project: General Interior Renovations of 250 College
St. Ground, 8, 9, 10, & 11th floors ADD # 01

CAMH RFP # 1175.23 date: 2023-08-30
HJA proj no: 22-48

This addendum forms part of the contract documents and is to be read, interpreted, and co-ordinated with all other parts. The cost of all contained herein is to be included in the stipulated bid price. The following revisions supersede the information contained in the original drawings and specifications issued for the above-named project to the extent referenced and shall become part thereof. Acknowledge receipt of this Addendum by inserting its number on the tender form. Failure to do so may subject bidder to disqualification.

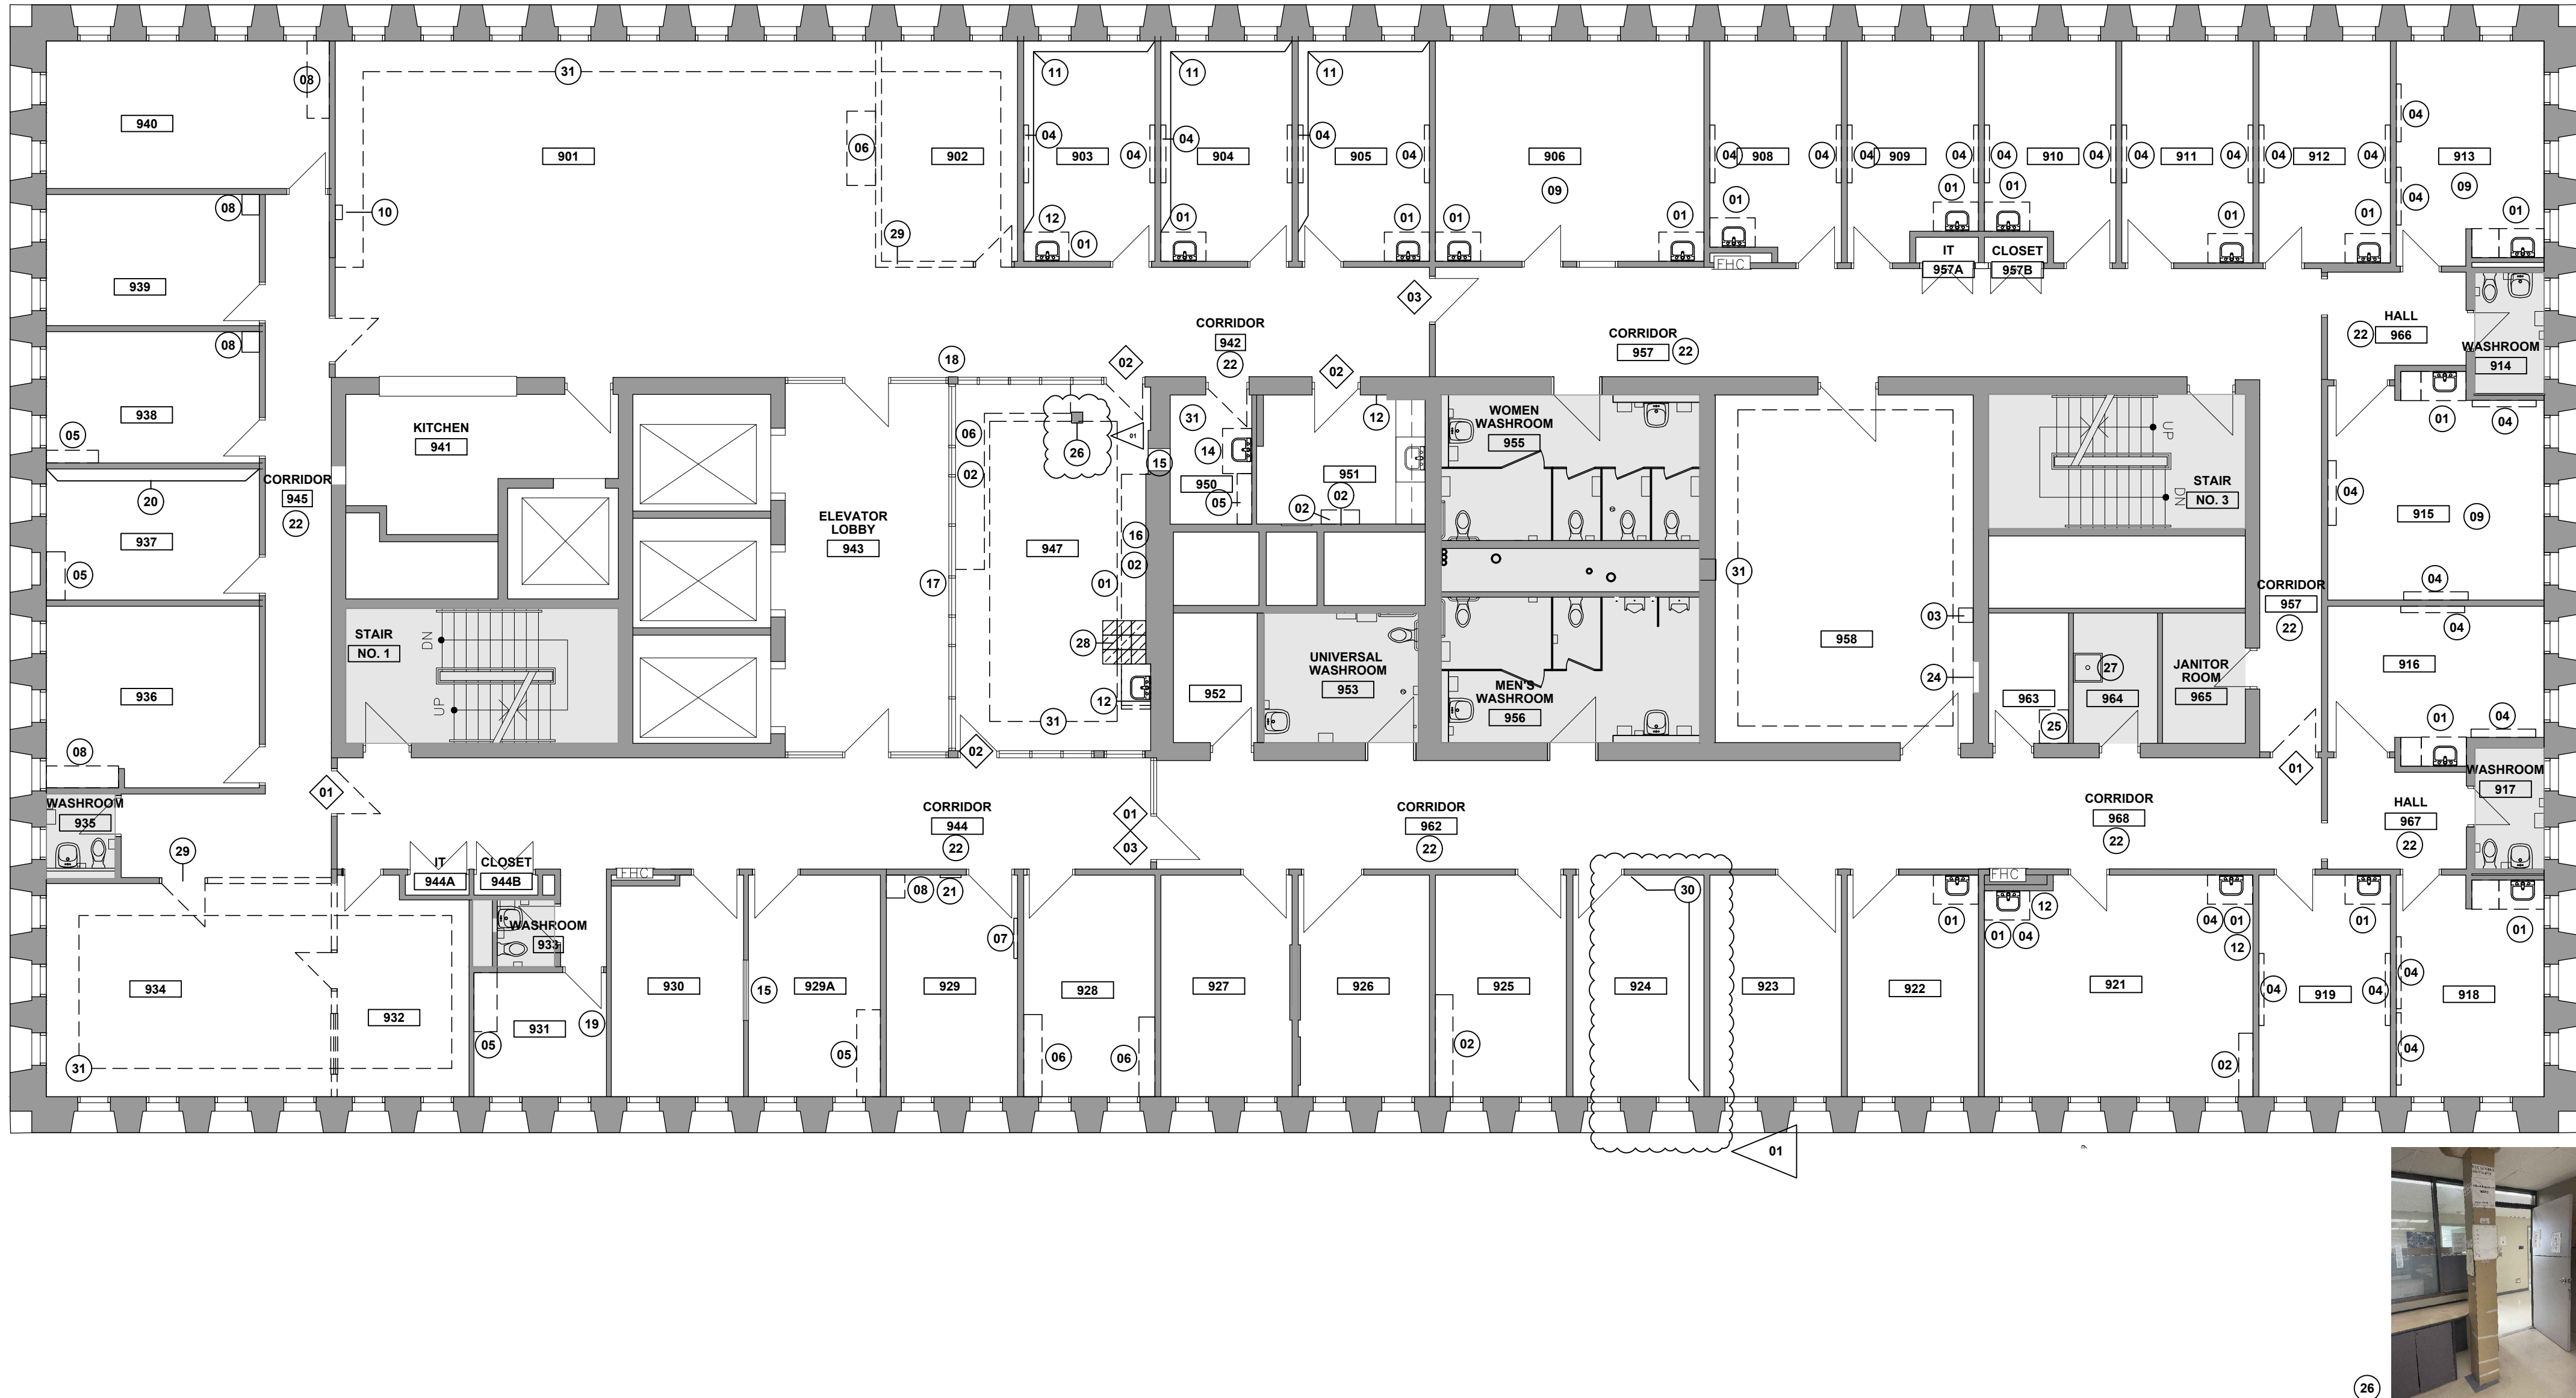
Question 4.5 Can you please provide some pictures of the roof by new mechanical work?

Response: The CU unit location on the roof has been revised. The photo indicates the roof area at the revised location. Low roof at mechanical penthouse level.

A-110

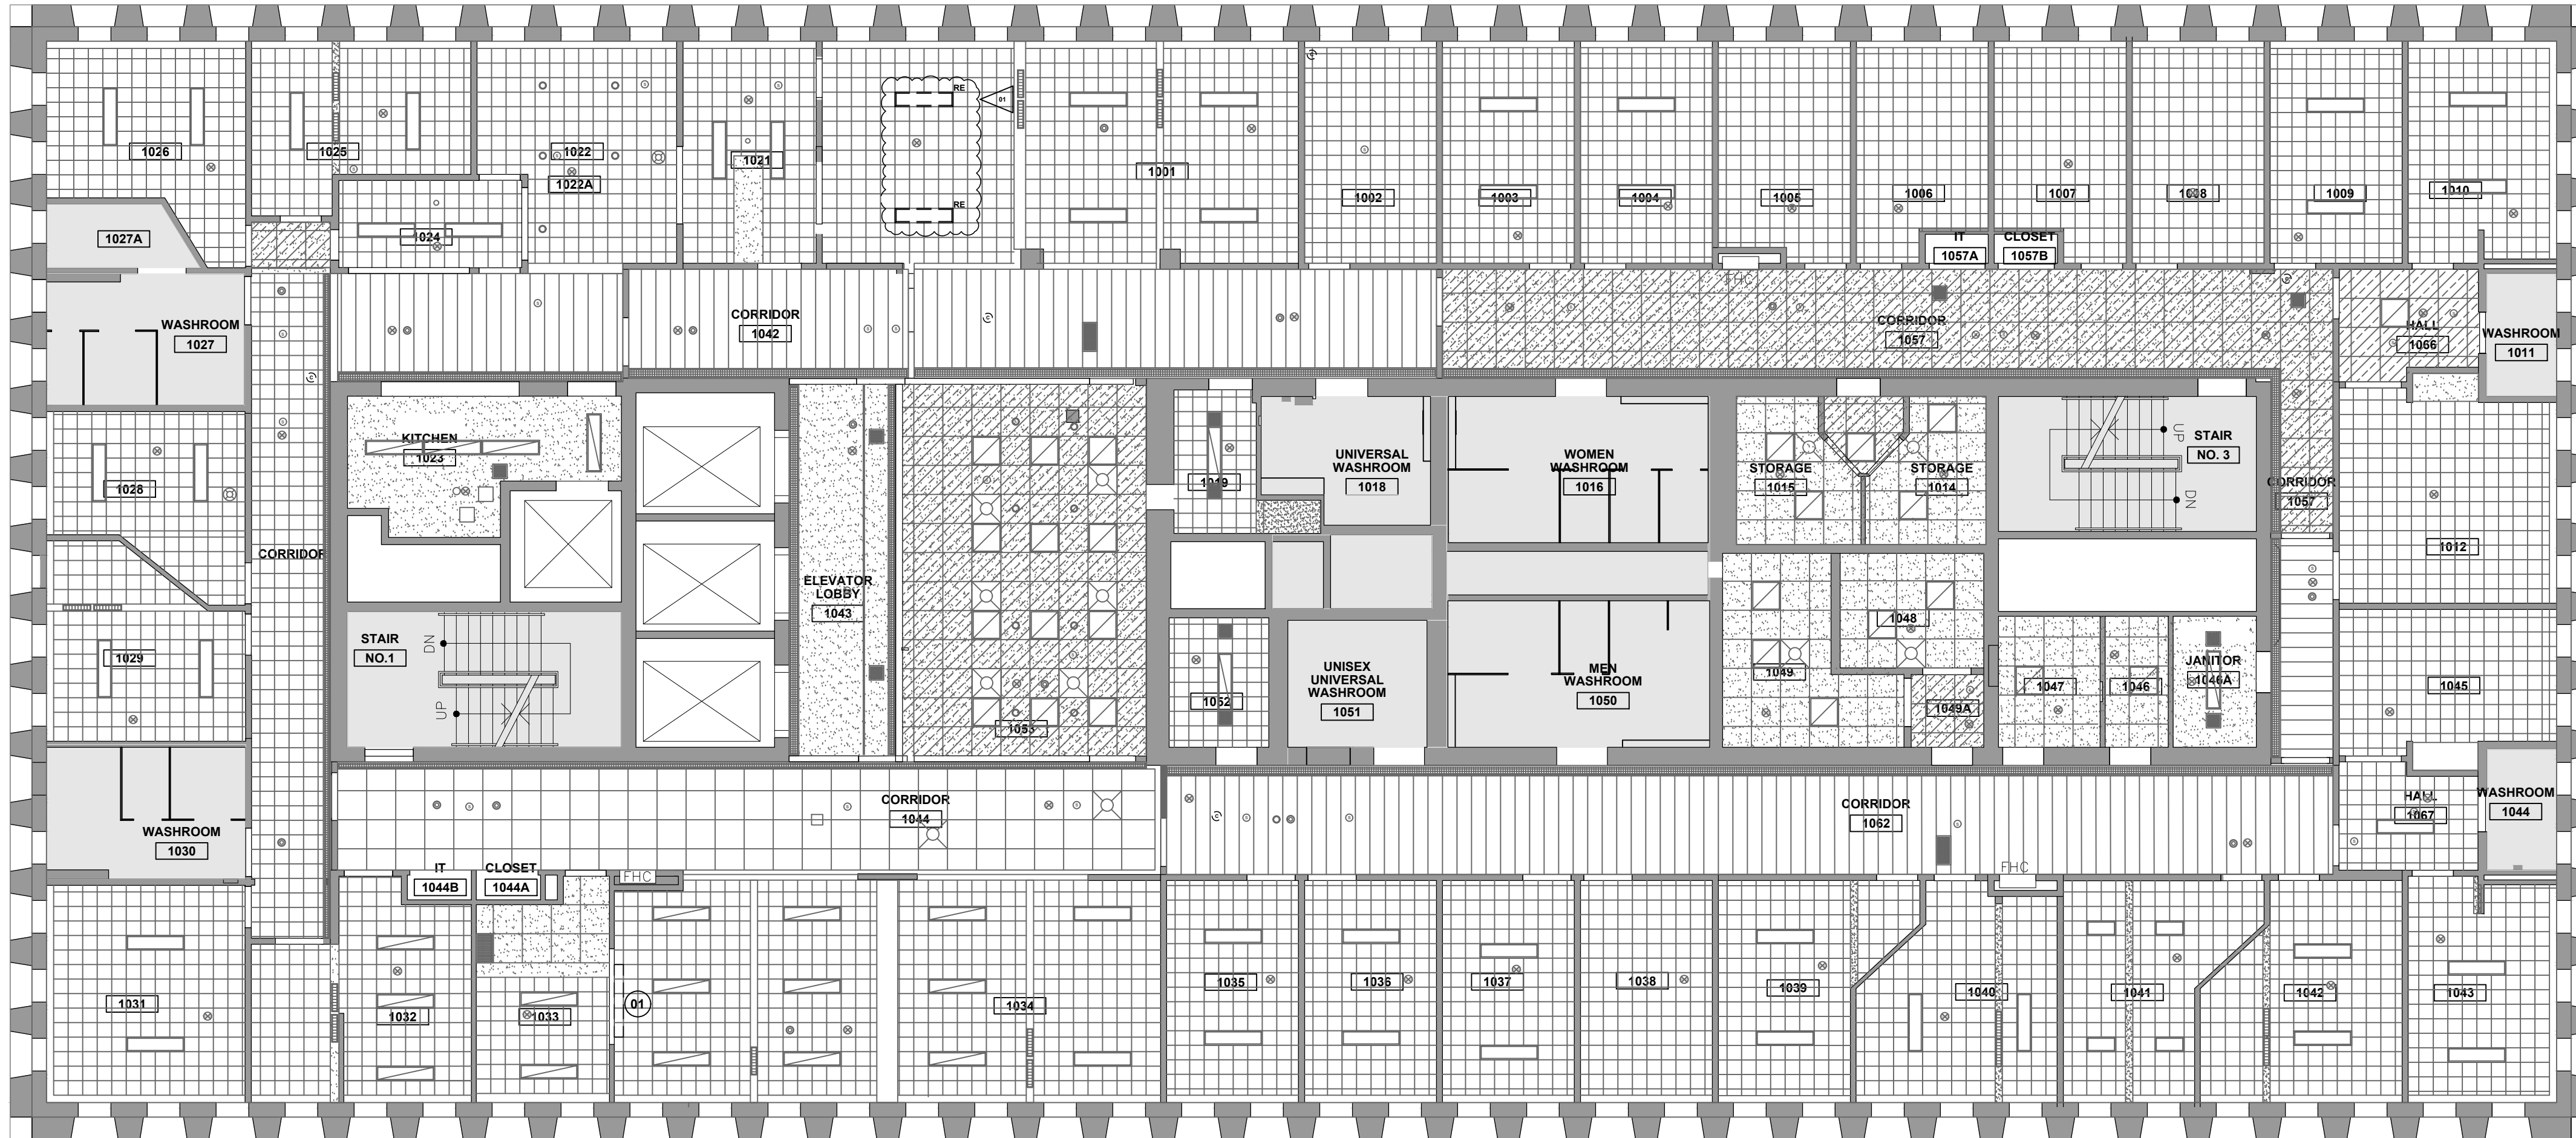
- Question 3.13 Which Drawings takes precedence for the quantity & locations of existing cameras to be removed on the 9th floor? A-110 show 8 to be removed, E-306 shows 11. A-110 shown below referencing E-3.06

- Response: **E-306 takes precedence.** All cameras are to be removed in all areas as noted on Electrical plans as 'R'.
- Question 3.14 Please confirm which notation we are to follow. A-111 notation (shown below) request existing cameras to remain. E-308 show the cameras to be removed. Please advise. Please confirm if 3rd party fire alarm verification is required on this project.
